In the Matter of)
) Docket 50-344
PORTLAND GENERAL ELECTRIC COMPANY,)
) (Control Building Proceeding)
et al)
)
(Trojan Nuclear Plant))

I hereby certify that on June 29, 1979, Licensee's letter to the Director of Nuclear Reactor Regulation dated June 29, 1979 and an attachment entitled "Request for Additional Information, Trojan Nuclear Plant, Proposed Control Building Design", have been served upon the persons listed below by depositing copies thereof in the United States mail with proper postage affixed for first class mail.

Trojan Nuclear Plant
Docket 50-344
License NPF-1

Enclosed are responses prepared by Bechtel Power Corporation to an additional 14 of the 50 questions submitted in your letter of May 18, 1979. In accordance with our discussion with your staff, we expect to transmit responses to the remaining questions by July 6.

Figure 3-9

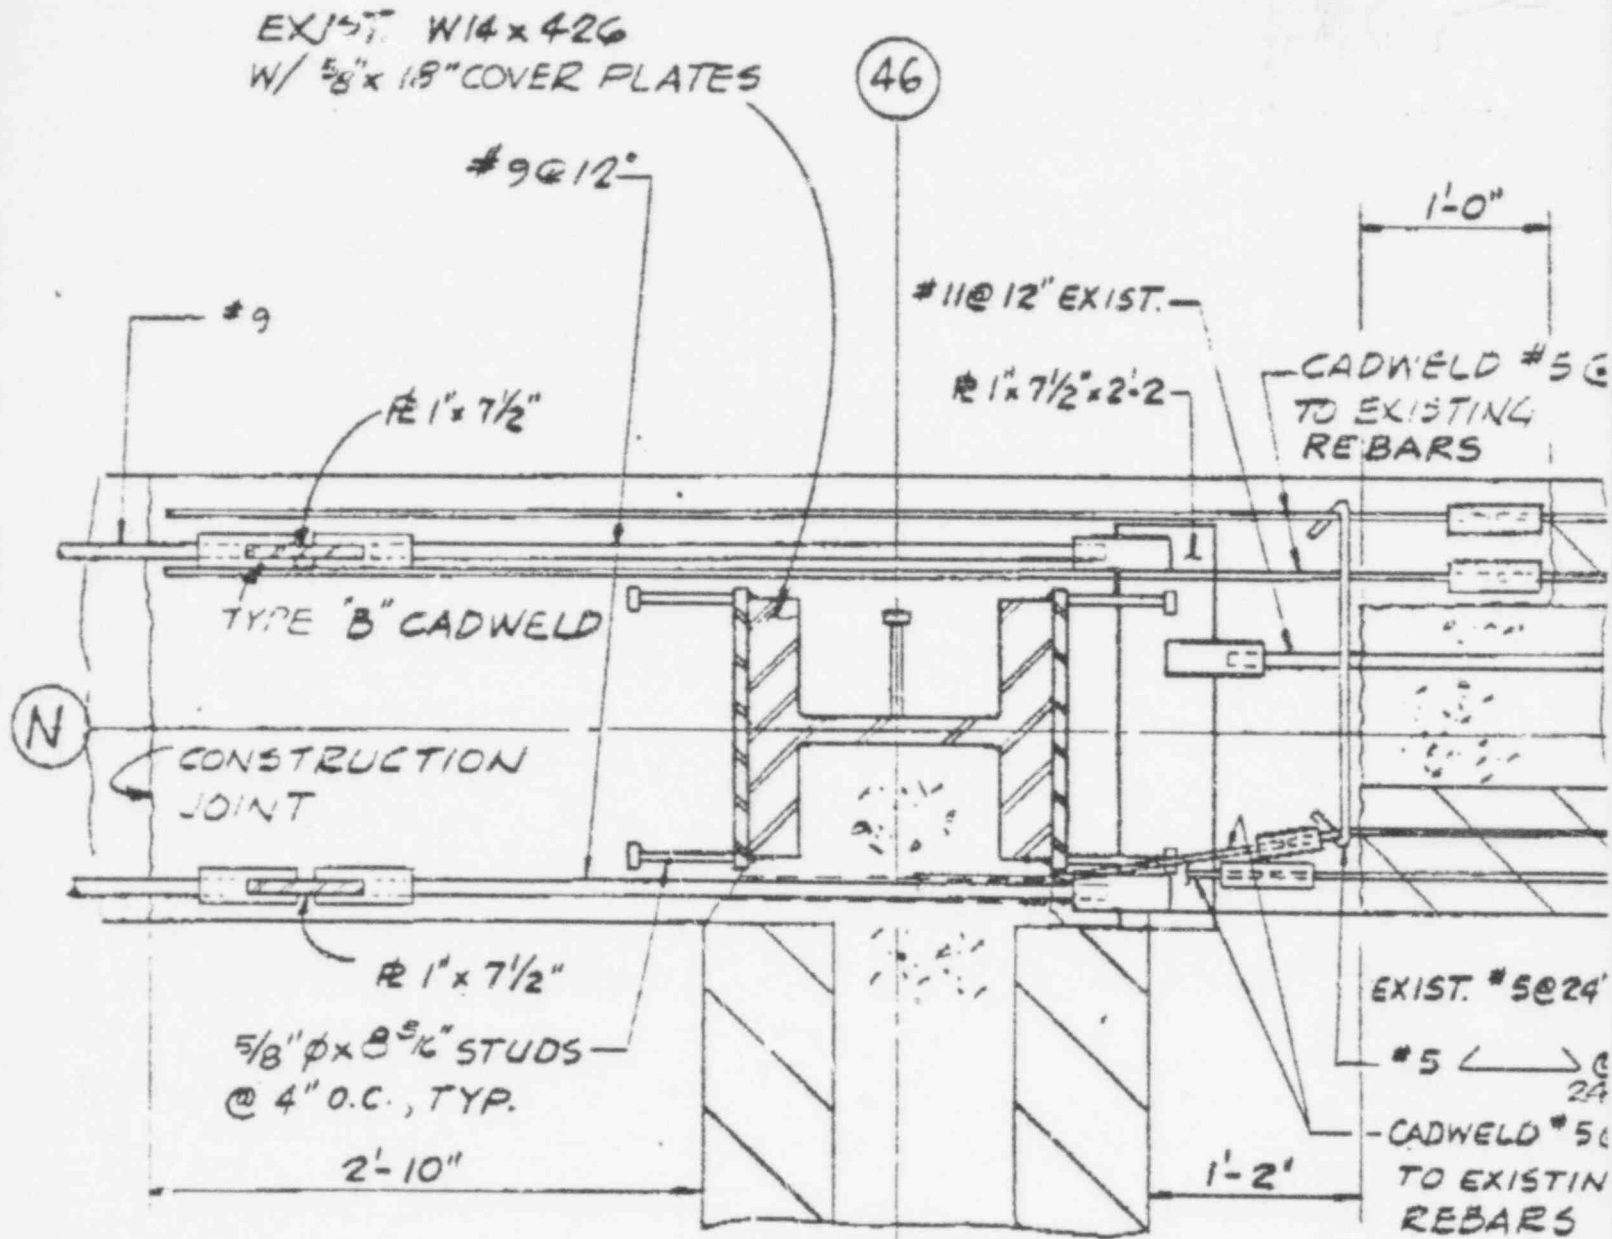
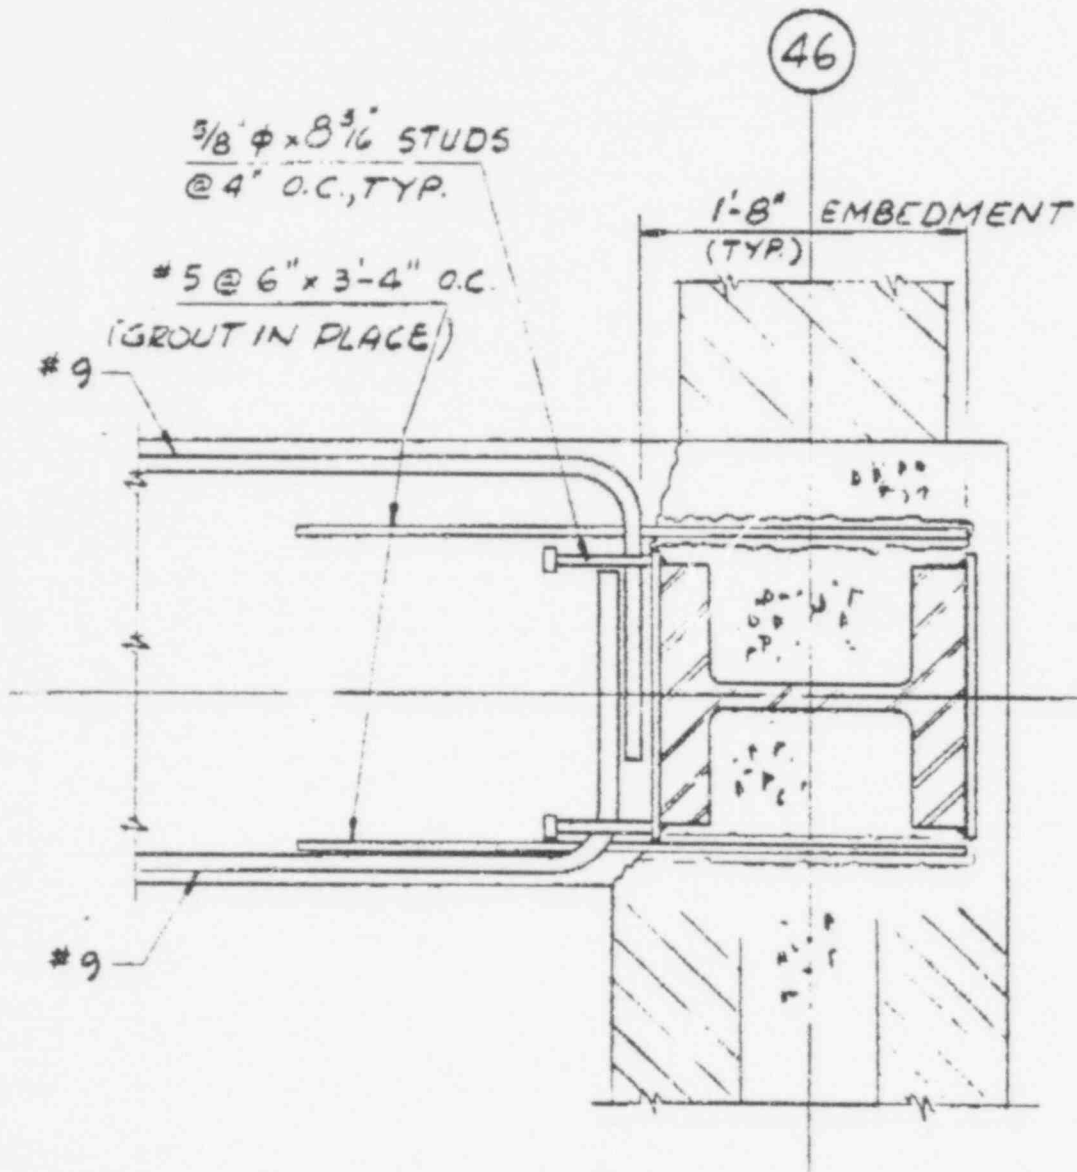
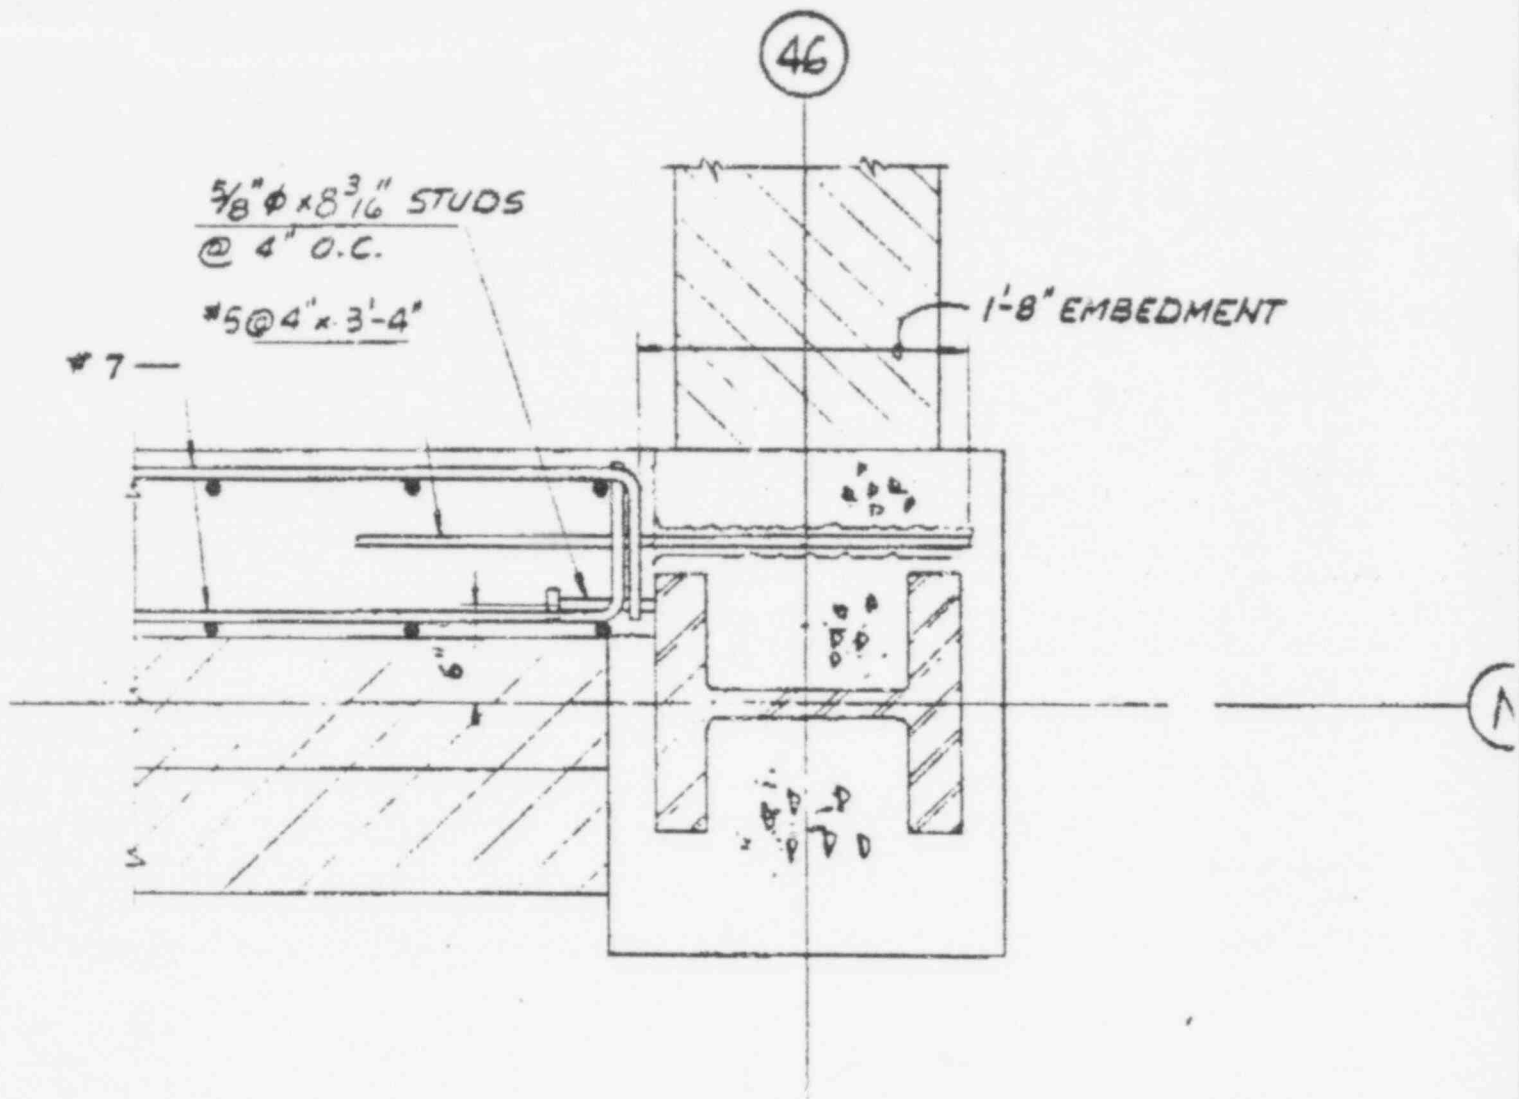
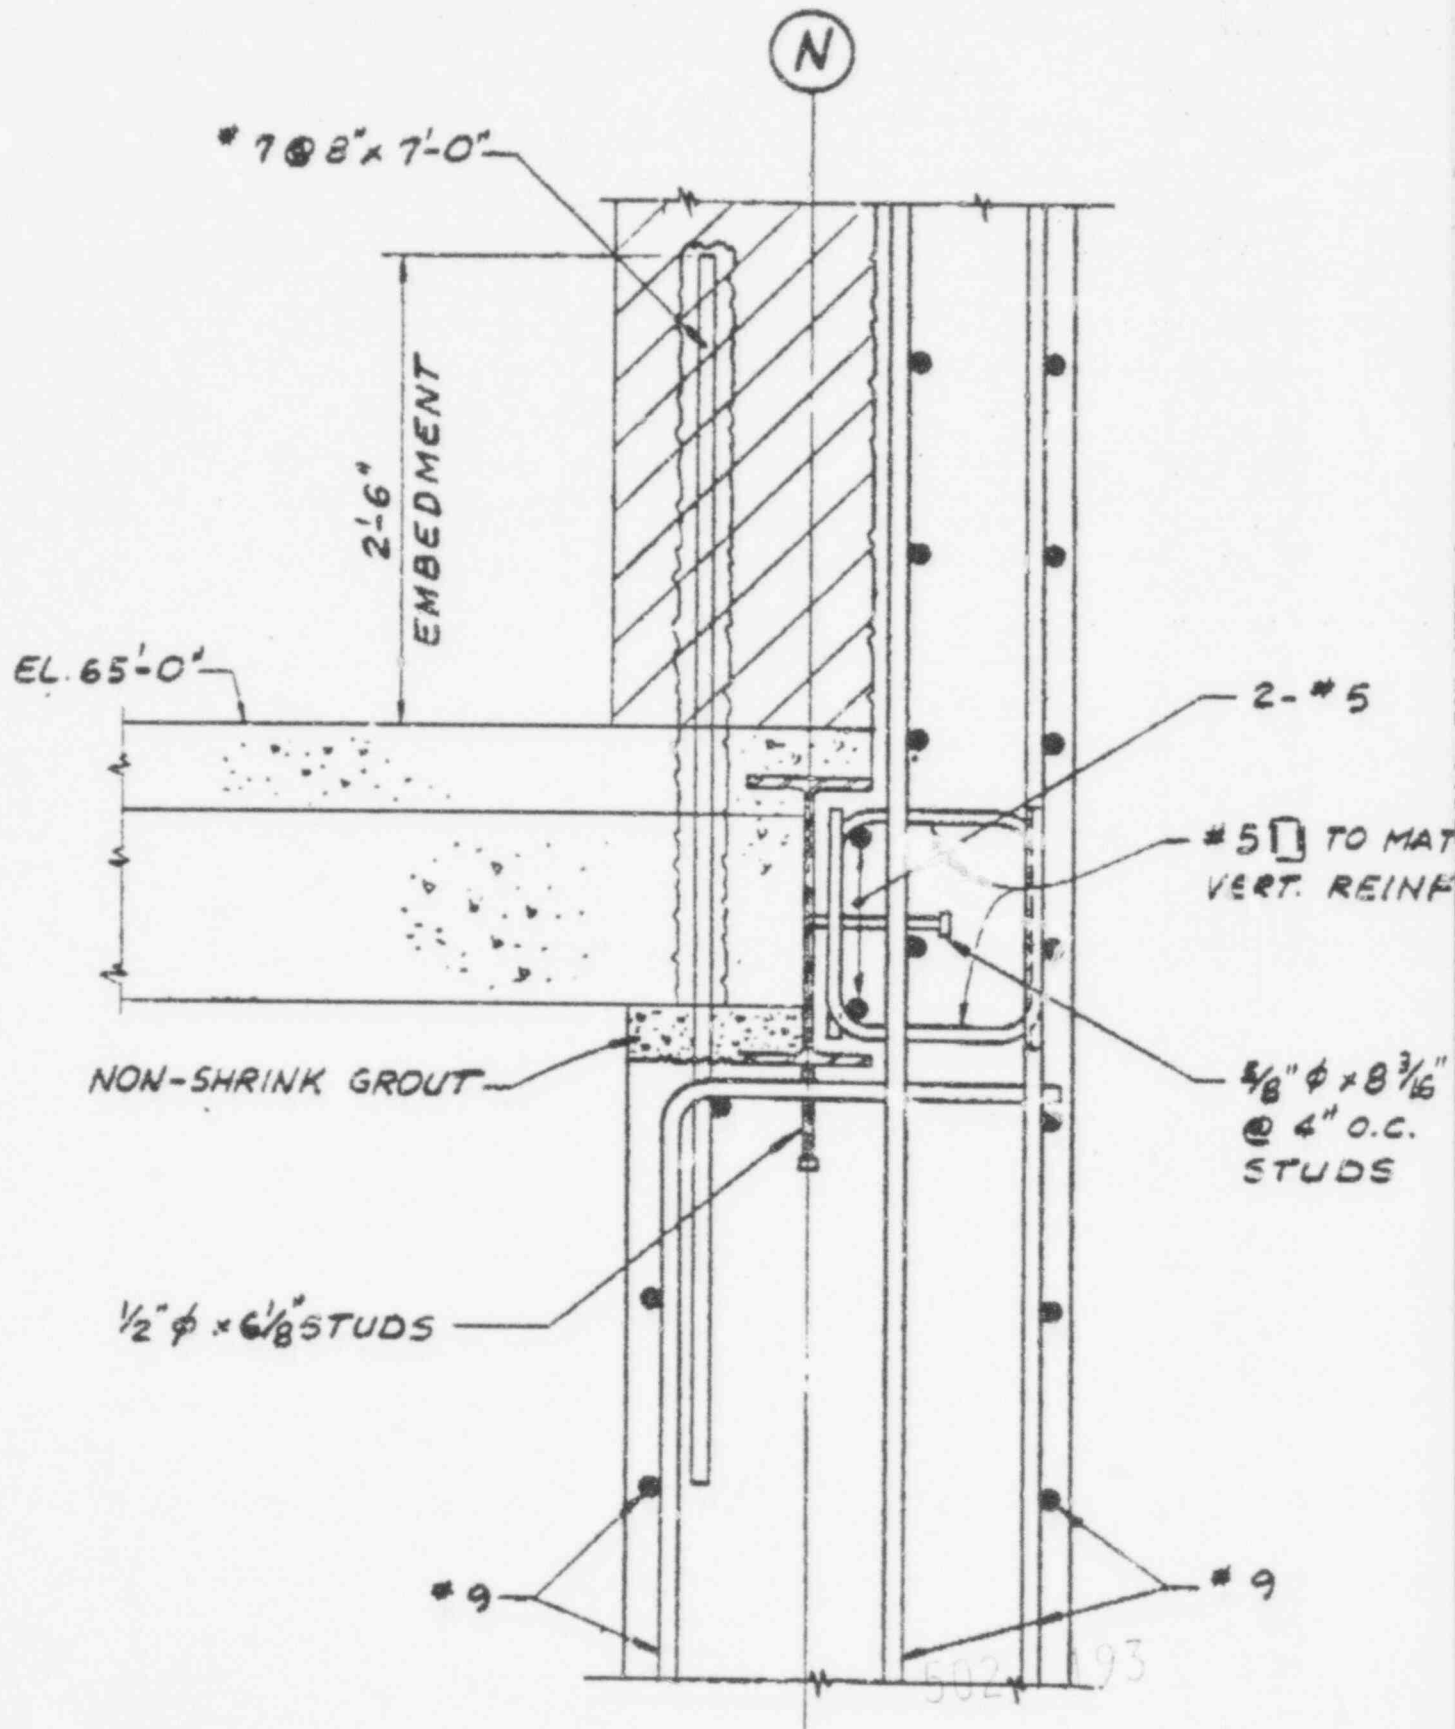
Provide clear, detailed sketches and descriptions of the connection interfaces of the additional walls to the existing structure. Additionally, describe the methods by which the effects of concrete creep and shrinkage (causing tension in the walls and/or a reduction in assumed dead weight) have been factored into the design of these additional walls. Describe and justify in detail the design and the procedures for the connections of the new walls to the existing structure.

Detailed sketches of the connection interfaces between the new walls and the existing structure are attached. The final design may require some minor revisions to the actual sizes and spacings of the rebar and studs. The sketches show representative connection details that will be used. The connection interfaces are discussed below.

Typically, where steel beams occur at a horizontal interface, studs are used to transfer shear forces and vertical rebars are used to transfer tension forces. At horizontal interfaces where steel beams do not exist, vertical rebars make the connection. In some cases friction type A-490 bolts are also used in the connections between the new walls and the existing concrete.

The typical treatment for vertical interfaces is to expose the columns and weld studs to them. New rebars are spliced with the exposed horizontal existing rebars by cadwelding. Drilled and grouted horizontal rebars are also used to make the connections.
